Service Bulletin

Bulletin No: 2003-1-17

Subject: Improper Gasline Hose Routing

Model: 2003 Mountain Cat 900 (159 in.)

Fig. 1

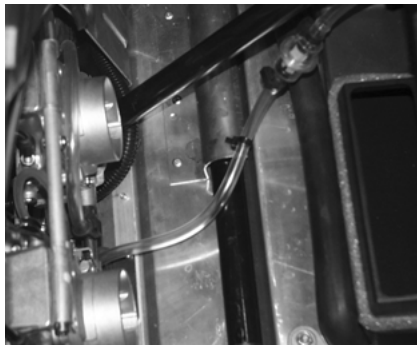
Condition: It has been determined that existing Gasline Hose (p/n 0610-016) between the gas tank and the fuel pump was incorrectly routed and secured to the driven shaft protector bracket. This incorrect positioning will cause the hose to wear against the bracket resulting in severe damage to the hose. See Fig. 1 for the improper routing and positioning of the hose.

Solution: Inspect all affected snowmobiles to determine if the gasline hose is improperly routed and secured to the driven shaft protector bracket.

If the hose is improperly routed and secured (see Fig. 1), remove the gasline hose from the cable tie.

■ **NOTE:** When the hose is properly routed and not secured to the bracket, the hose should lie under the steering post and along side the air silencer assembly (not underneath).
